**RE: Former Kidd/Portsmouth Landfill – Remedial Action Work Plan Addendum  
Portsmouth, Rhode Island  
DE Project #: 2057-001**

**RE: Former Portsmouth Landfill**  
**Portsmouth, Rhode Island**  
**DE Project #: 2057-001**

DiPrete Engineering has received the review comments in regards to the above referenced project. The following responses are provided and revisions are incorporated within the accompanying submission.

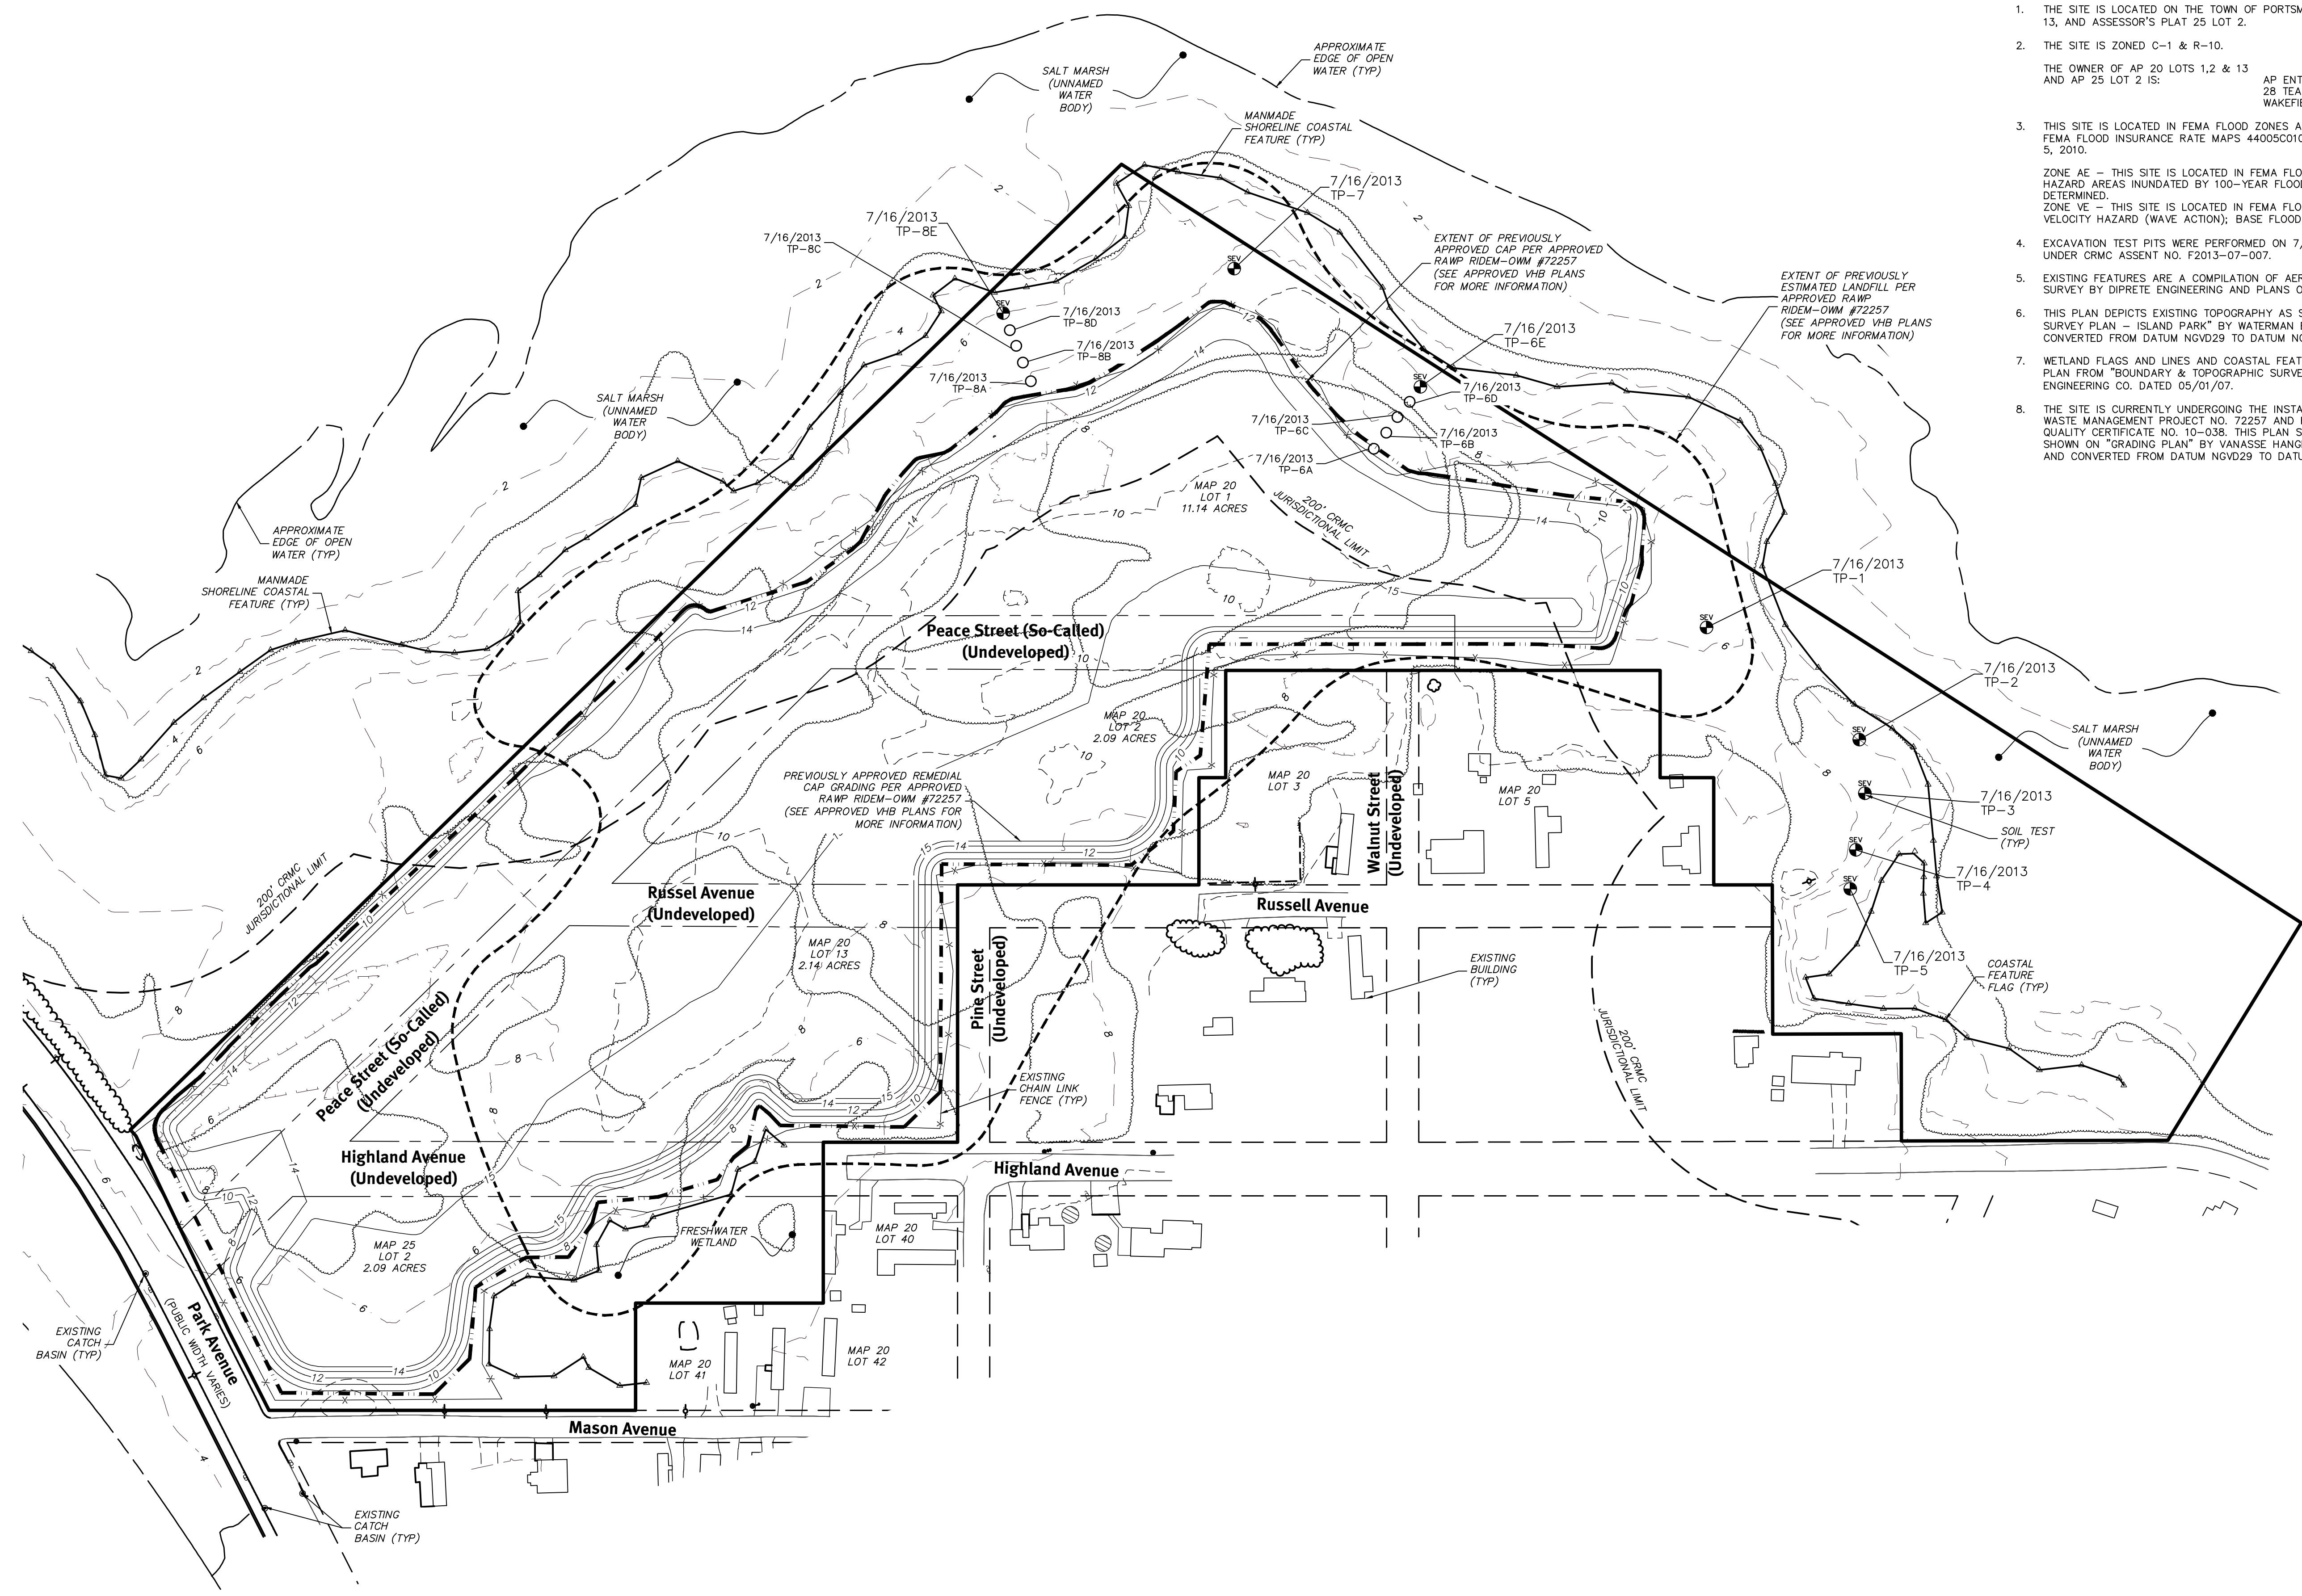
1. Sheet 1 shows the locations of the test pits, however discussions with staff onsite indicate that the locations on the map are the furthest extent in a series of test pits where trash was found. The plan should be revised to indicate that a series of test pits were dug and the test pit shown on the plan indicates the furthest extent of excavation.

**Response: As discussed onsite, for TP-6 and TP-8, a series of test pitting was done beginning near the edge of the previously approved limit of work and extending out toward the property boundary. The intent was to extend testing only as far toward the coastal feature as needed to reach the limits of trash. Due to site constraints and impacts that were obvious at the surface, this was unnecessary at the majority of the test pit locations (1-5, and 7). In either case, testing extends no closer than 10' to the property line or coastal feature. These initial test pit locations have been added to the plan.**

**Existing Conditions Plan**  
**Former Kidd/Portsmouth Landfill**  
Park Avenue  
Portsmouth, Rhode Island

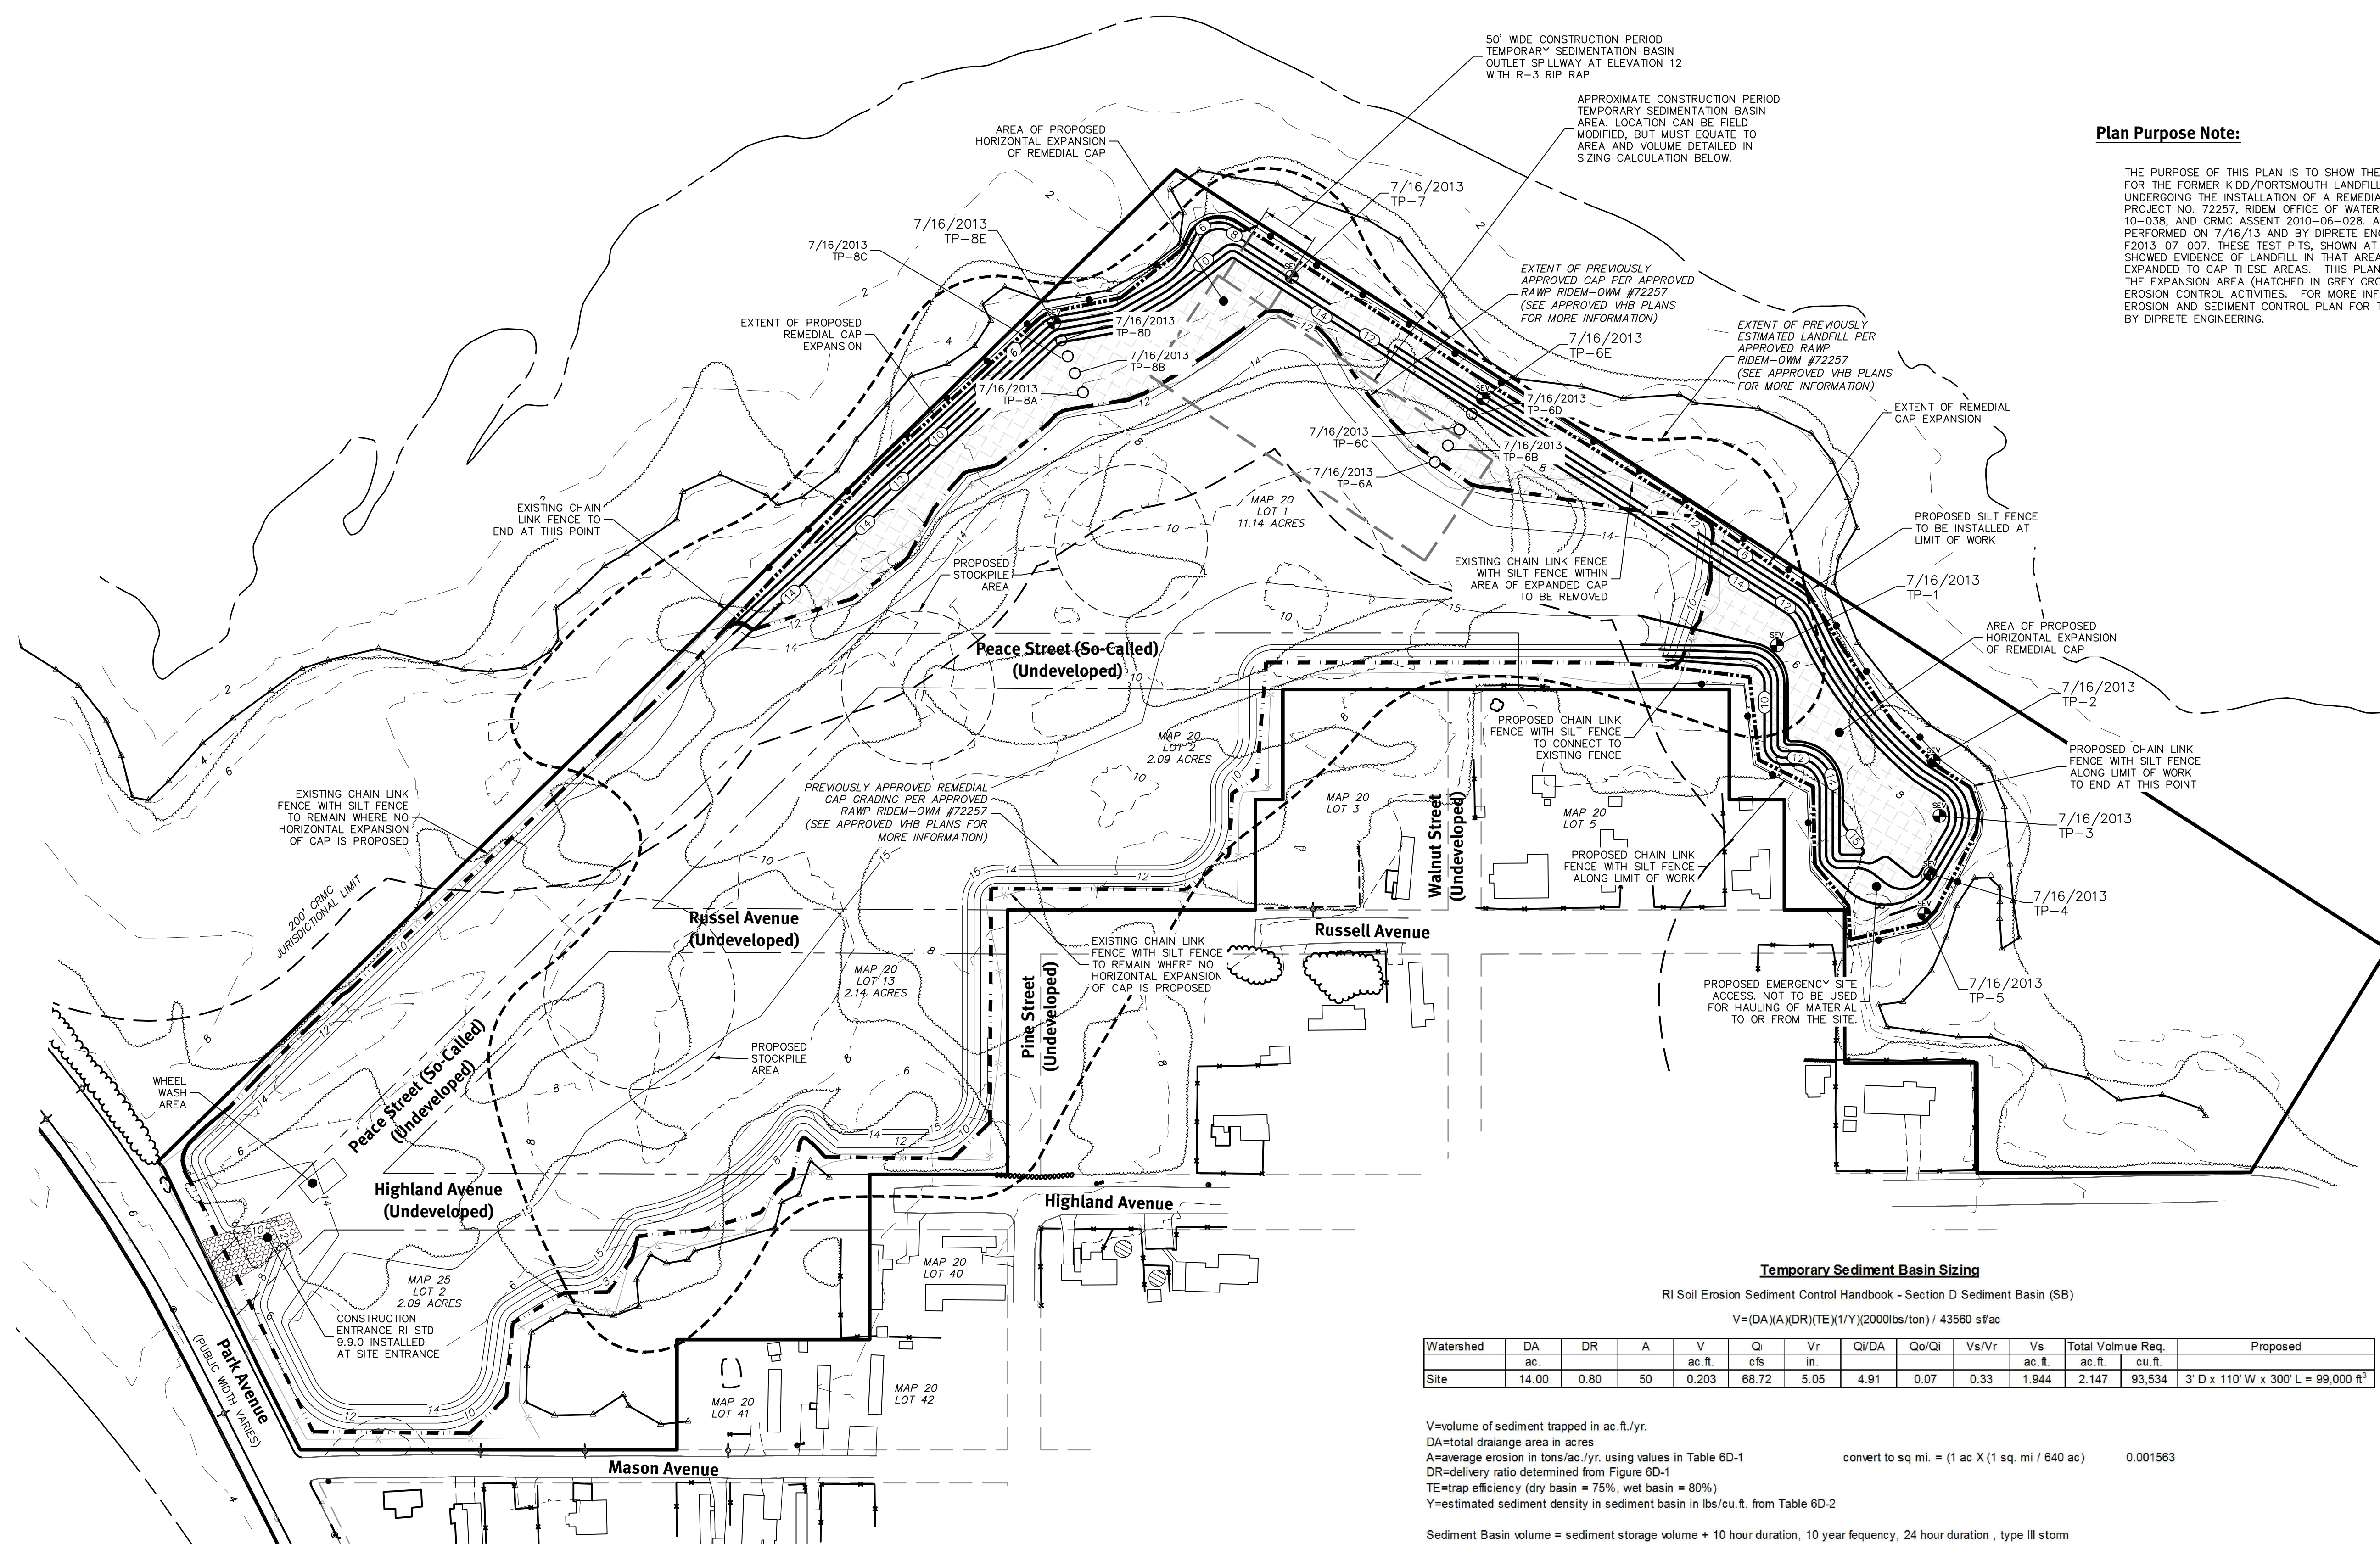
3. Unlike current abutters to the work areas, the properties east of TP-3, 4 and 5 are not located on fill material. Furthermore, there is recreational use (ballfield) nearby. To that end, APE should address how the vegetative buffer around the work area could be preserved and enhanced if possible, even if this slightly reduces the area to be capped.

**Response: The proposed limit of capping extended to the east beyond the proposed emergency access connection to the north end of Russell Avenue. The proposed cap has been reduced 20' - 30' to increase the buffer to the east. This increases the buffer to the house immediately east of TP-5 to approximately 160' and the buffer to the ball field to over 250'.**
